Illinois Department of Transportation

SUBJECT: St. Louis Downtown Airport
Cahokia Heights, Illinois
St. Clair County
Illinois Project Number: CPS-5163
SBG Project Number: 3-17-SBGP-TBD
Contract No. SD065
Item No. 04A, April 24, 2026 Letting
Addendum A

NOTICE TO PROSPECTIVE BIDDERS

RELOCATE/RECONSTRUCT
TAXIWAY B, PHASE 4:
CONSTRUCT FROM
TAXIWAY B1 TO B4

STORM WATER
POLLUTION
PREVENTION PLAN

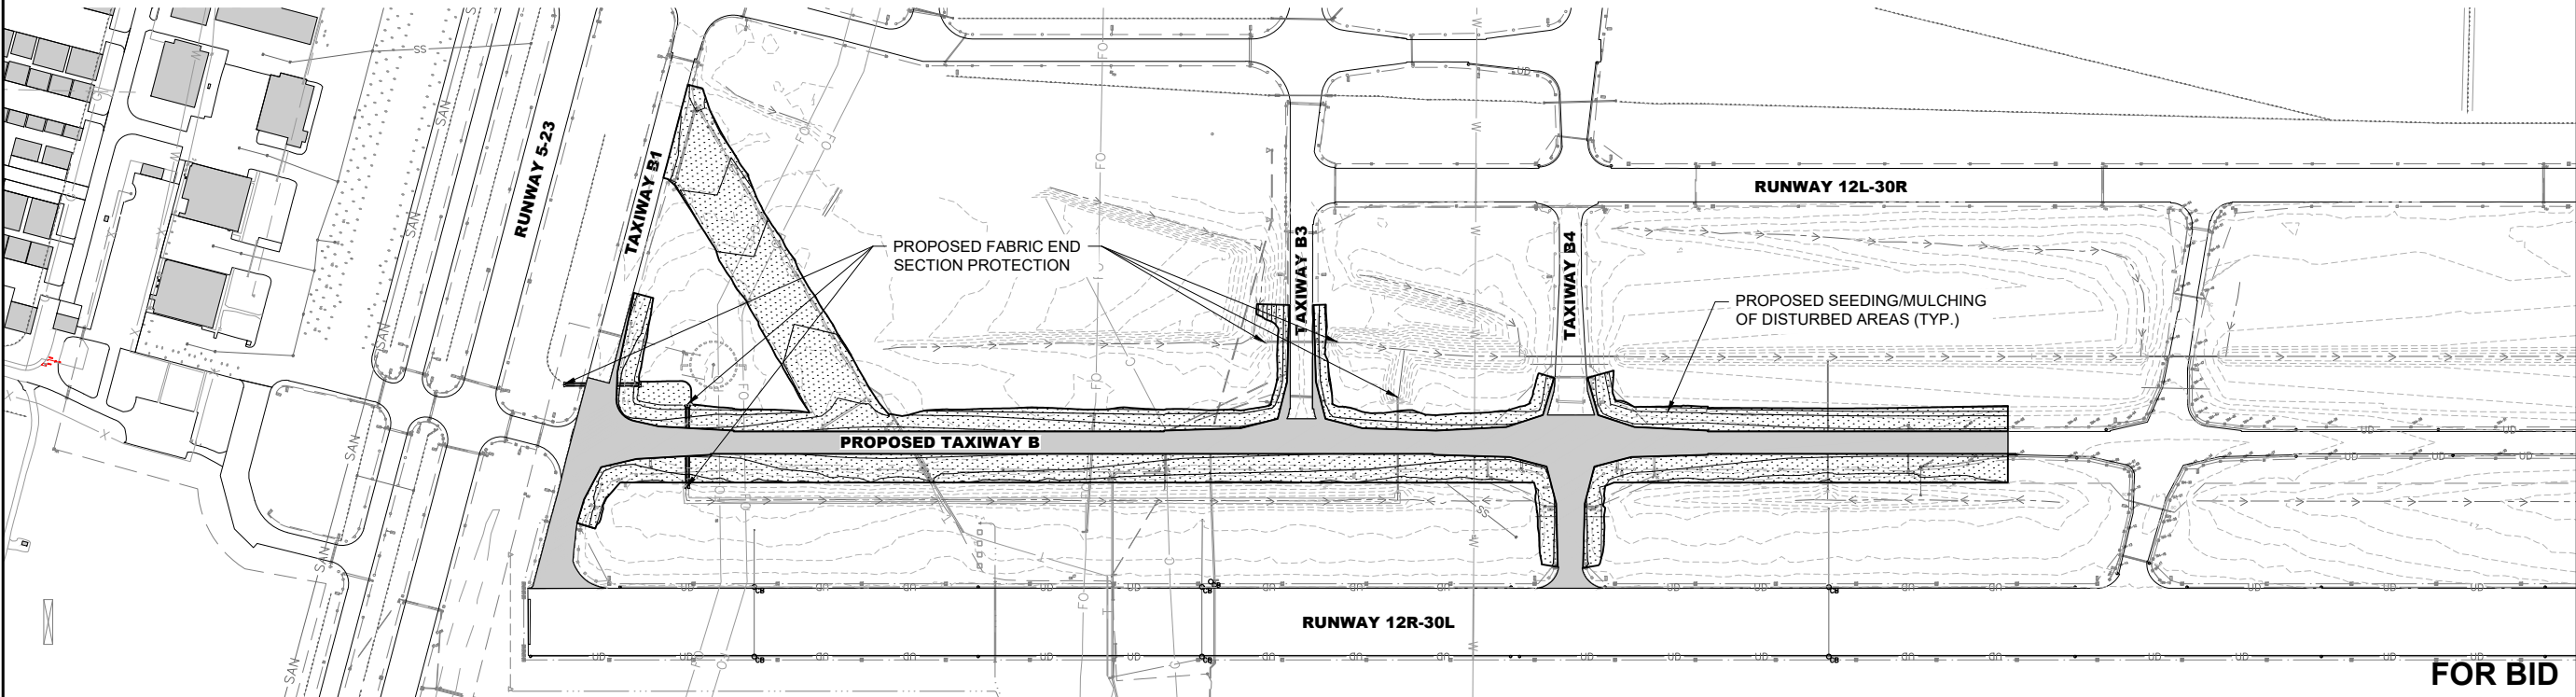
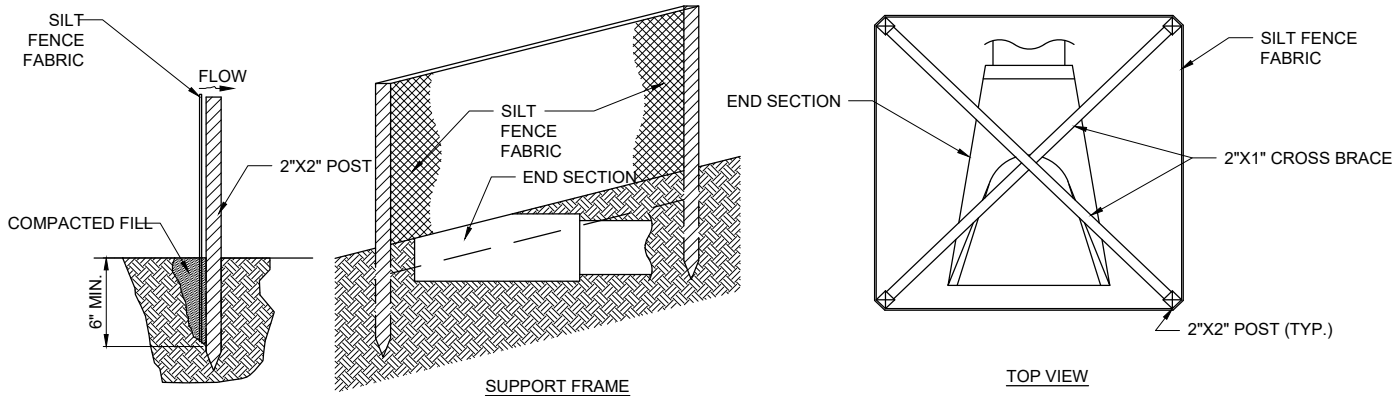
Plan Sheet 3, Summary of Quantities, is revised per the attached.
Plan Sheet 4, Scope of Work, is revised per the attached.
Plan Sheet 58, Storm Water Pollution Prevention Plan, is revised per the attached.
Plan Sheet 71, Taxi Guidance Sign Schedule – Sheet 1, is revised per the attached.

NO.	DATE	STOCKPILE REVISION		
		DES	DRN	REV
1	4/9/26	JRH	JRH	BSS
